Addendum No. 1
City of Coquitlam
Tender No. 97424
Harbour Chines Area Utility Replacements
 (Consists of 5 Pages)

Issue Date: March 11, 2025

Project: **2026 UTILITY UPGRADES HARBOUR CHINES AREA**
 Description: **STORM SEWER**
 CRESTWOOD DRIVE - STA. 4+028 TO STA. 4+286
 File: 06679-C4-300

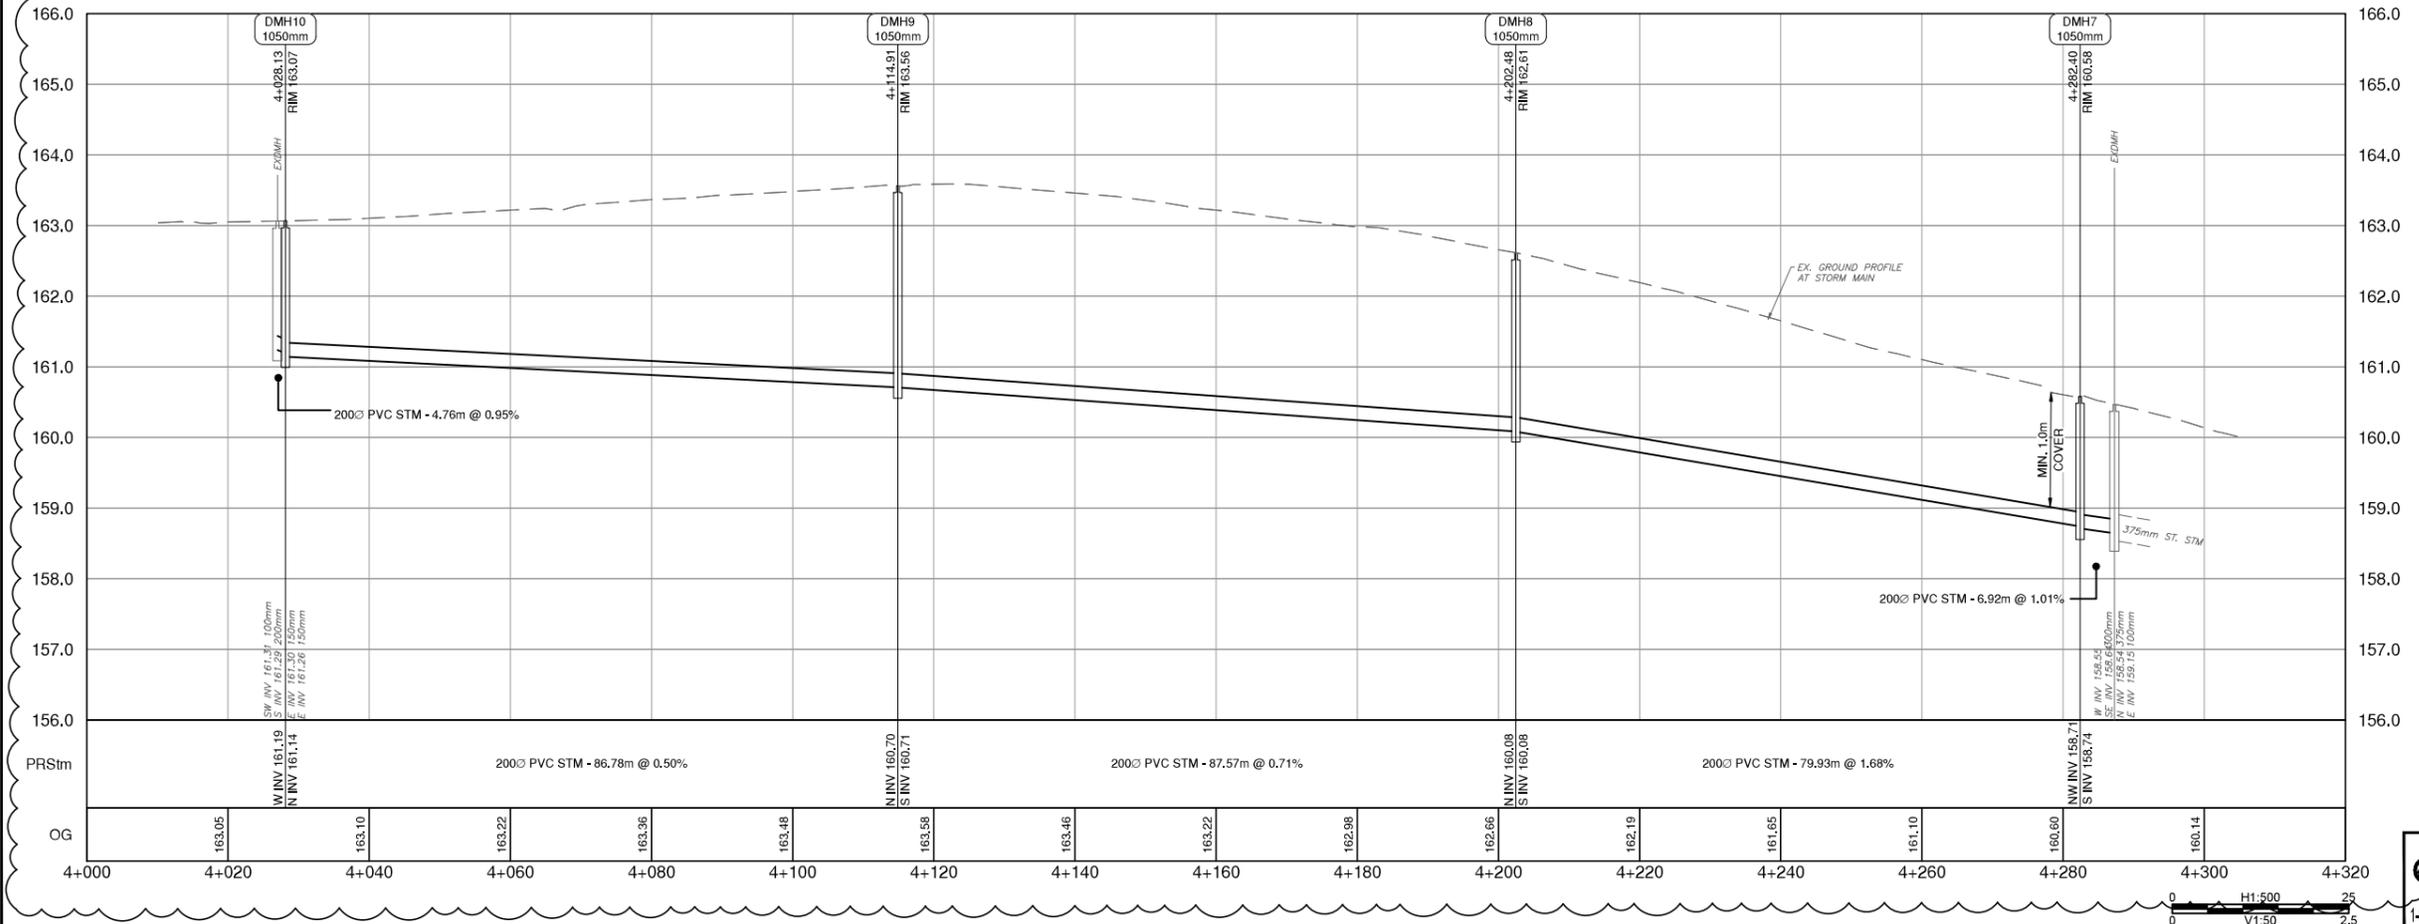
TITLE	SHEET NO.	REVISION NO.	DATE
STORM SEWER - CRESTWOOD DRIVE - STA. 4+027 TO STA. 4+287	04 of 04	0	2026.02.26

TITLE	SHEET NO.	REVISION NO.	DATE
STORM SEWER - CRESTWOOD DRIVE - STA. 4+028 TO STA. 4+286	04 of 04	1	2025.03.06

No.	Date	By	Revisions	Eng.
1	2026-03-06	MS	IFT - ADDENDUM #1	MH
0	2026-02-26	MS	ISSUED FOR TENDER	AG
